SERVICE BULLETIN

EQUIPMENT: RT-406F

DATE: January 21, 1999

BULLETIN NUMBER: WSB RT-406F-1

Figure 1

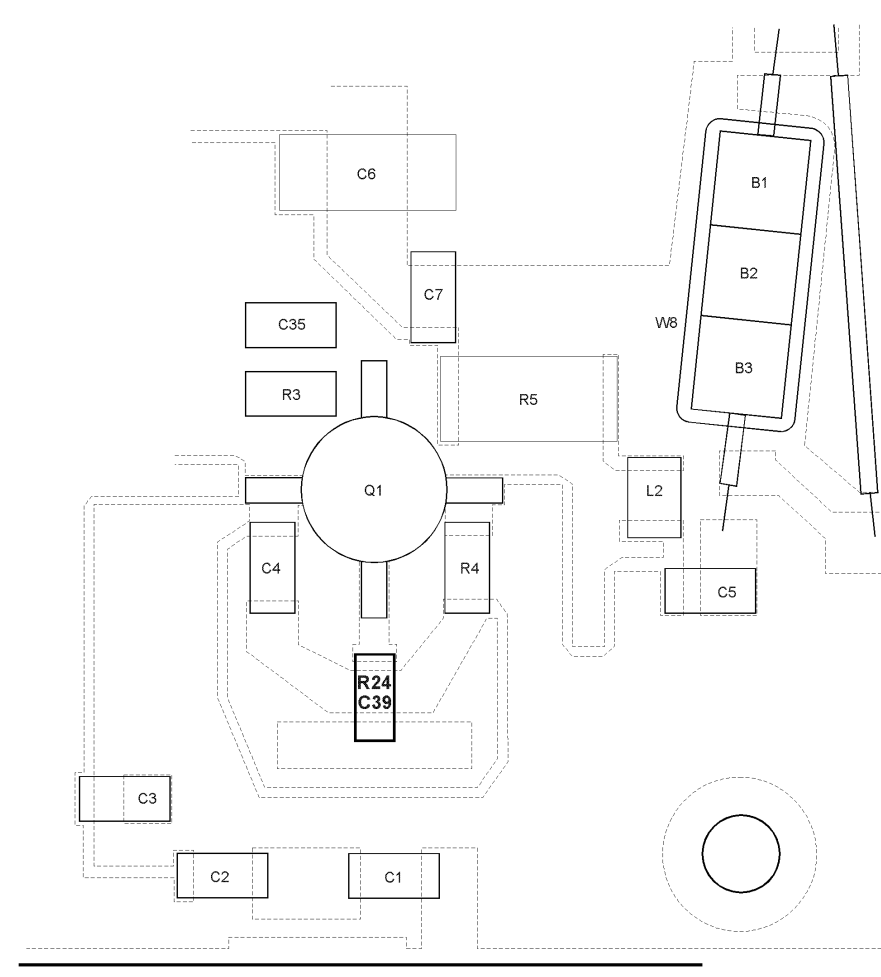
This modification consists of rework to the 300-15920-01 Power Amplifier assembly to add a resistor and a capacitor to Q1, change a resistor on Q1 and adding a capacitor to the output of Q2.

2. Locate resistor R3. Remove and discard it.
3. Replace R3 with item 2.
4. Install item 2 (R24) as shown in fig. 1. Install item 1 (C39) on top of item 2.
5. Install item 3 (C40) as shown in Fig. 2. Scrap away the solder mask on the ground plane side to enable soldering of item 3.
6. Mark the service bulletin number on the circuit board and on the outside of the cover of the RT module 300-014366.
